Fortis Garments Ltd. Extended Building

2nd September 2019

Observations

Column stresses above normal design limit

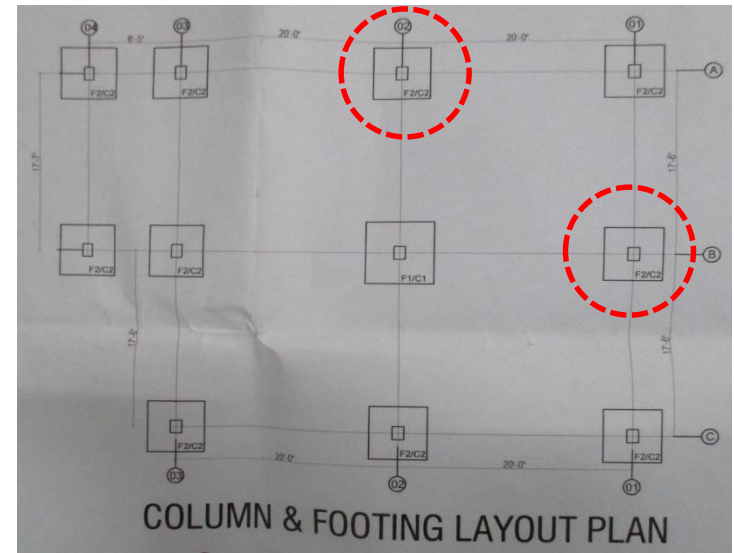
Cursory calculation shows that the peripheral columns are overstressed at ground level that exceeds the acceptable design limit. Detail Engineering Assessment (DEA) to be carried out based on in-situ concrete and rebar strength.

Concrete core holes remaining unfilled

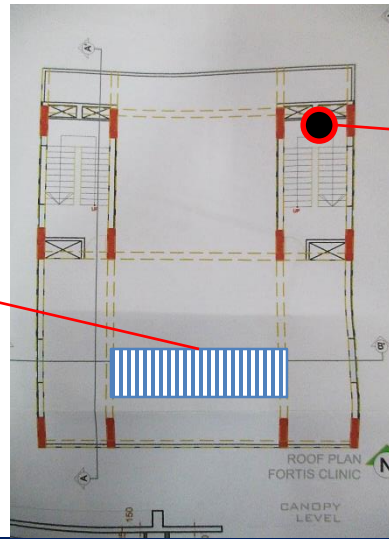
Concrete core samples have been taken from the column and beam of the Medical and Sub-station building. The void of core cutting had not been filled with proper materials. The factory is required to take immediate step to fill the voids.

Lack of as-built documents

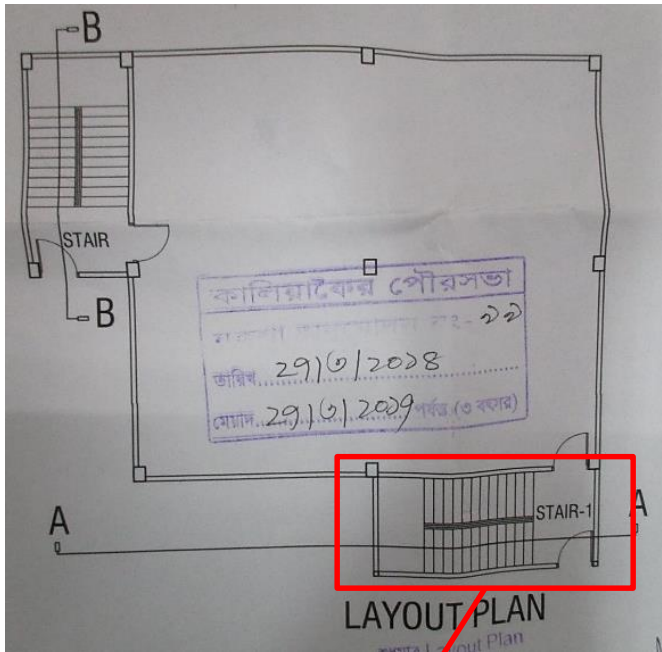
Undocumented lightweight roof and plastic water tank was observed on the roof of Medical Building.

There was no beam layout drawing for the Sub-station Building. Also, discrepancies were found between as-built condition and provided drawings.

No floor loading plan

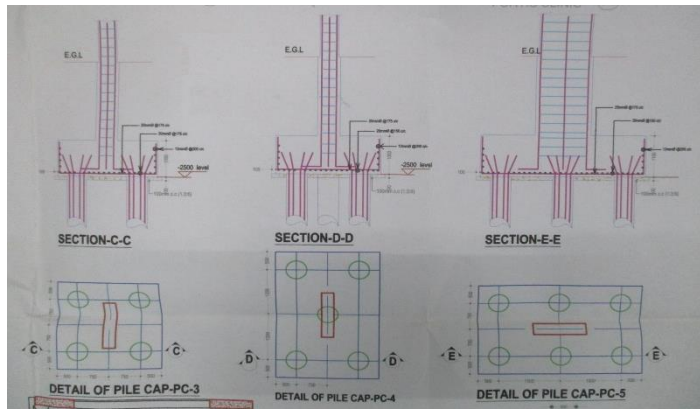
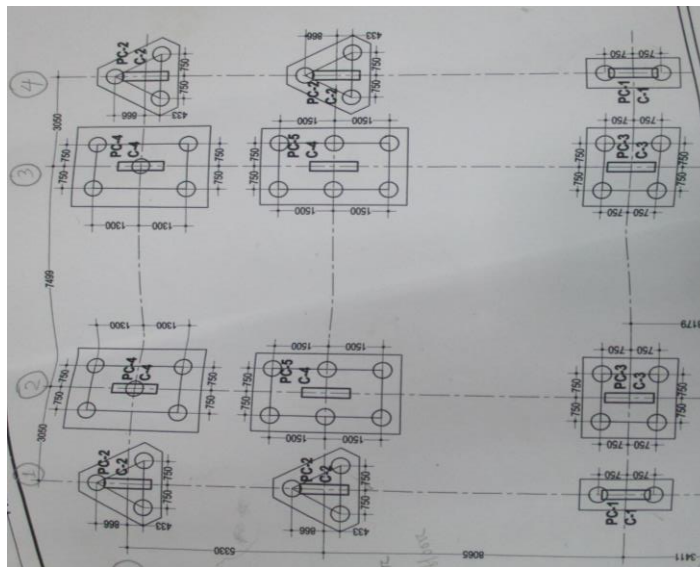
There was no floor loading plan for the Medical and Sub-station building. During inspection, floor loading more than 3 kPa was observed in the sub-station building. The factory is required to produce floor loading plan for each floor of the buildings.

No soil investigation report

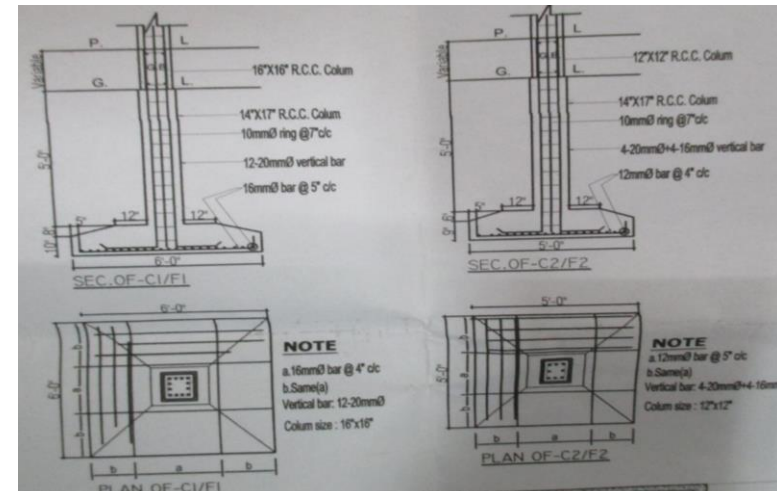
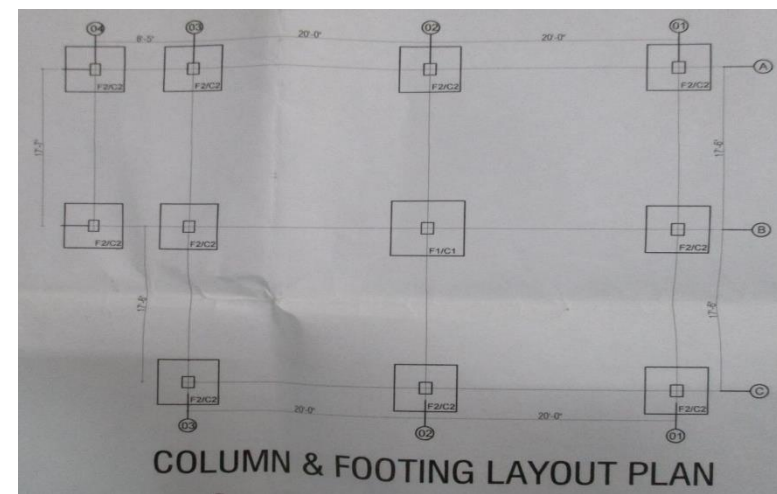
The soil investigation report was not available on site. So, the foundation capacity could not be verified. The factory is required to investigate the soil bearing capacity and verify the foundation adequacy accordingly.
